## ***Letter for Change Order 003***

### **Reference Project: Pavement Repairs for Silverlake – Phase II**

SILVERLAKE PAVEMENT REPAIRS - PHASE II  
CO 003: CR 59 ROADWAY IMPROVEMENTS  
MAP OF WORK LIMITS

SILVERLAKE PAVEMENT REPAIRS - PHASE II  
CO 003: CR 59 ROADWAY IMPROVEMENTS  
MAP OF WORK LIMITS

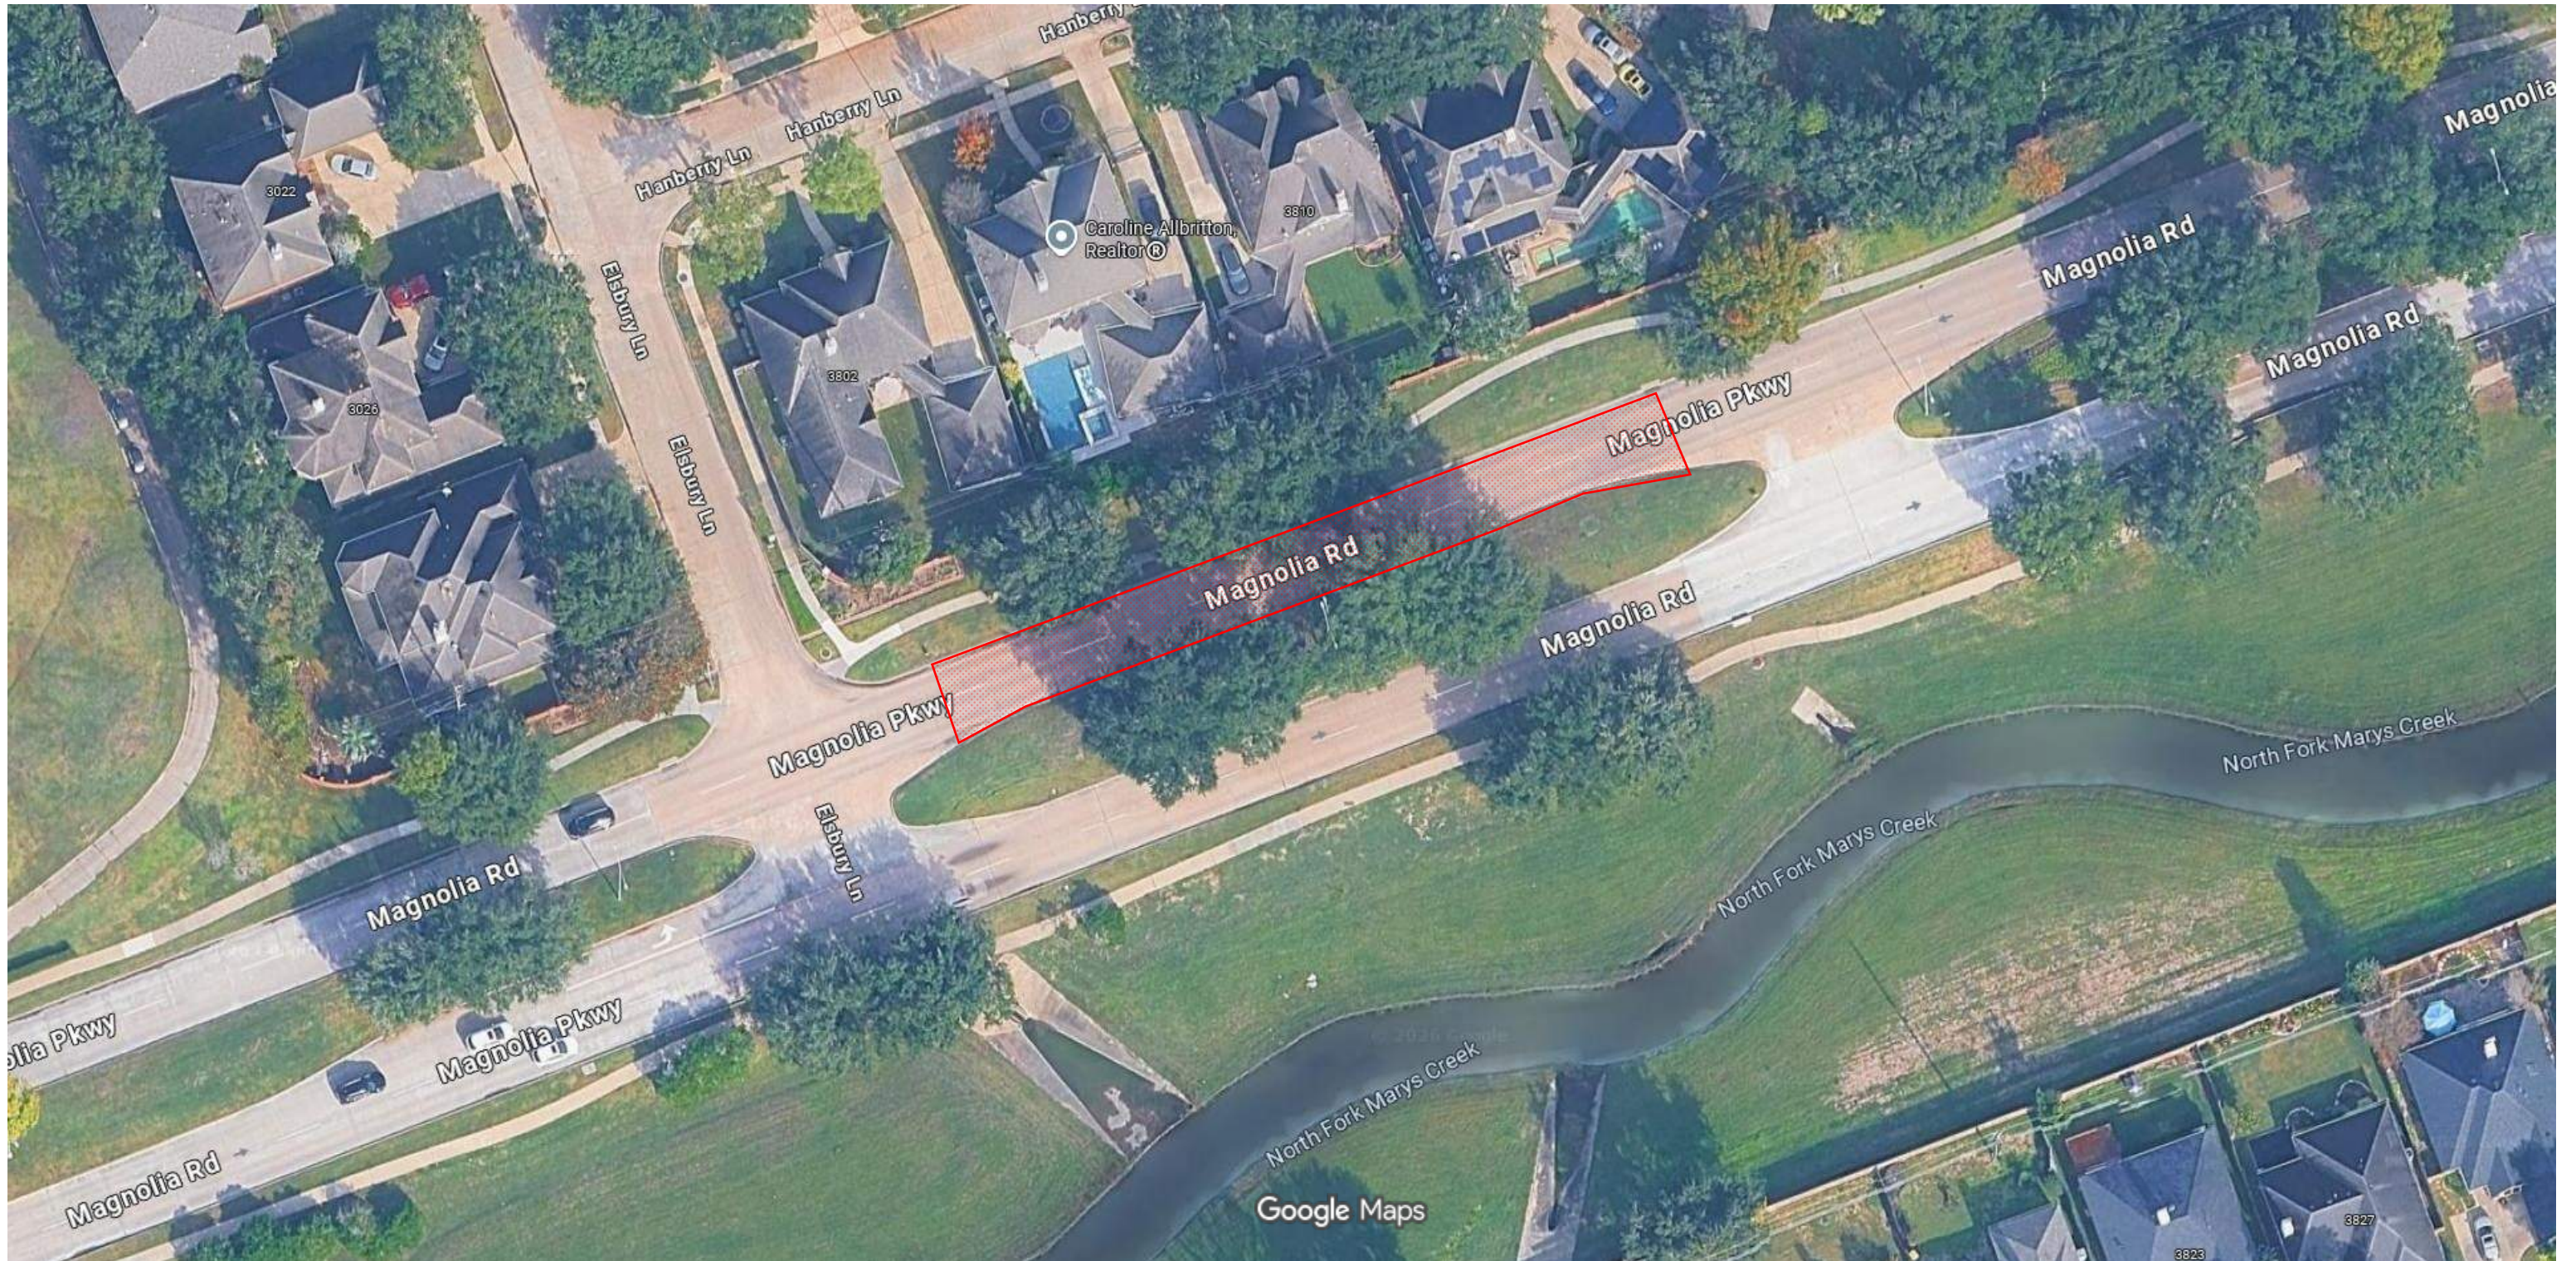
At the conclusion of the field meeting, an 709-SY area at CR 59 was identified for full-depth roadway repairs. The County requested a *Proposal for Pricing* from TECA to perform full-depth concrete roadway repairs at the identified location.

AREA OF PROPOSED WORK
